# 4.12 Improvement of Road Safety - Ruttleys Road - Mannering Park

TRIM REFERENCE: DA/204/2007/A - D02812706

# STAFF MEMORANDUM

COMMENTS FROM TRANSPORT PLANNING SECTION ON LETTER FROM EATON BUILDING MATERIALS (EBM), TO THE SECRETARY, MANNERING PARK PRECINCT COMMITTEE, DATED 12 OCTOBER 2011, REGARDING BANNING OF RIGHT TURNS INTO AND OUT OF 464 RUTTLEYS ROAD, MANNERING PARK.

The attached sketch (Figure 1) demonstrates the likely locations where vehicles may choose to carry out U-turn movements.

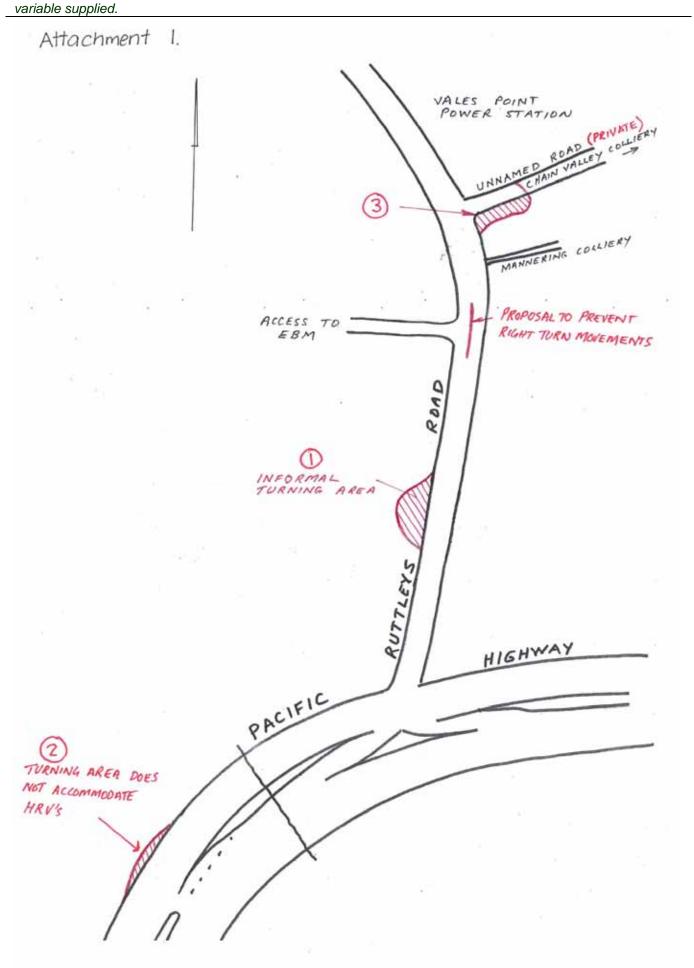
One such location is to the south of the EBM site, where there is an informal turning area, approximately half way between the EBM access and the Pacific Highway. The provision for right or U-turning turning vehicles at this informal turning area does not comply with acceptable Austroads standards. Improvements would be necessary on Ruttleys Road, at this location, to satisfy the required standards and to cater for Heavy Rigid Vehicles. This informal turning area is sometimes used by Council as a temporary stockpile area. Articulated vehicles cannot be accommodated within the informal turning area site and therefore these vehicle types, wanting to enter the site from the north and west, will need to stay on Wyee Road and access the site via the Pacific Highway Doyalson traffic signals. The use of this site for U-turns is undesirable without significant upgrade works and therefore an option is to fence the site or otherwise block it off from use for U-turns.

The second location is a U-turn area on the Pacific Highway, just south of the intersection with Ruttleys Road. This U-turn area provides for vehicles travelling south along the Pacific Highway. It does not accommodate 12.5 metre long Heavy Rigid Vehicles nor articulated vehicles.

The third location is identified in the letter to the Mannering Park Precinct Committee, by EBM, as a turning area to the north of its site, at the Unnamed Road (adjacent to the Vales Point Power Station) which leads to The Chain Valley Colliery. This turning area allows for safe movements from Ruttleys Road but is on private property and in its current state is unsuitable for vehicles to do U-turns. Also, the owners have made an application to the Department of Planning & Infrastructure (DOPI) for an extension of their mining operations for five years, which will allow it to increase the amount of coal extracted each year. Council requested in its submission to the DOPI that changes/improvements to this intersection be provided in conjunction with the proposed application. These works include physical closure of the old road so that vehicles, particularly the coal trucks, have to use an upgraded

"Unnamed Road" intersection with Ruttleys Road and not the remainder of the old road. This request, therefore, is in conflict with the area being used as a formal U-turn facility.

Traffic may choose to use yet other locations to carry out U-turns along Ruttleys Road. Any unsatisfactory sites that are found to be used for that purpose will need to be considered for the erection of physical barriers to prevent those turns if necessary.

The prevention of U-turns at the existing informal areas, south of the EBM site on Ruttleys Road will need to be ensured by means of physical barriers.

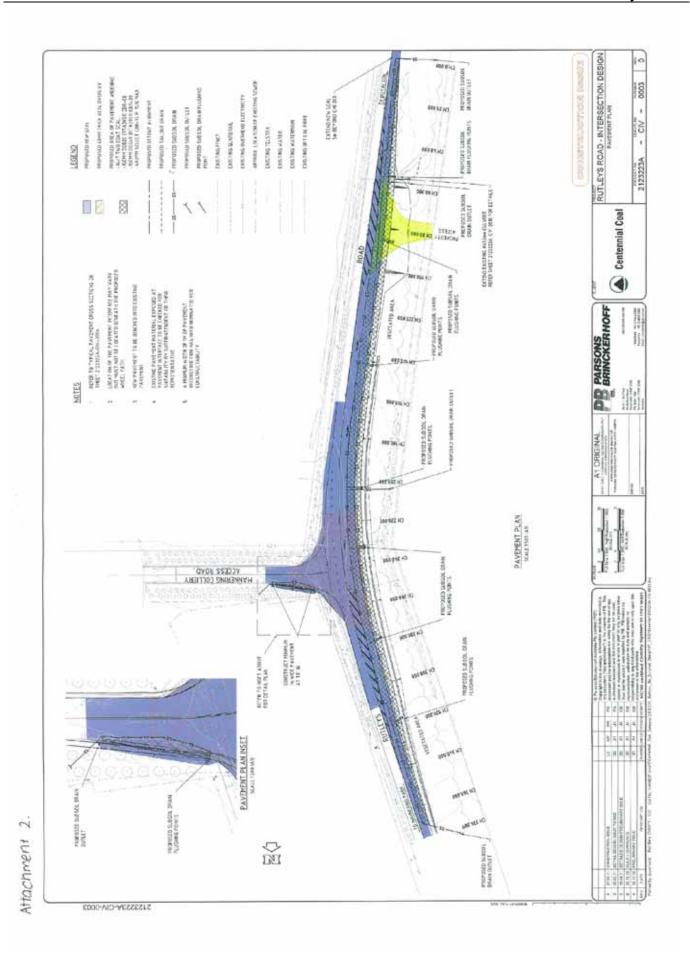
A proposal by Mannering Colliery involves upgrading work on Ruttleys Road, at its access point (see attached Figure 2). That work impacts on Ruttleys Road at the current access point to the EBM site. If Council did agree to the proposal to prevent right turn movements to and from the EBM site, it would be possible to retain the current location of the access to the EBM site and then incorporate the design of the necessary median strip into the design for the Mannering Colliery access, generally as shown on the attached aerial photograph (Figure 3). A detailed engineering design would be required. Isolated sections of central raised median strips at access locations, although not mandated by the relevant standards, sometimes benefit from appropriate street lighting and this matter would need to be considered by the applicant's engineering design consultant as part of an associated road safety audit.
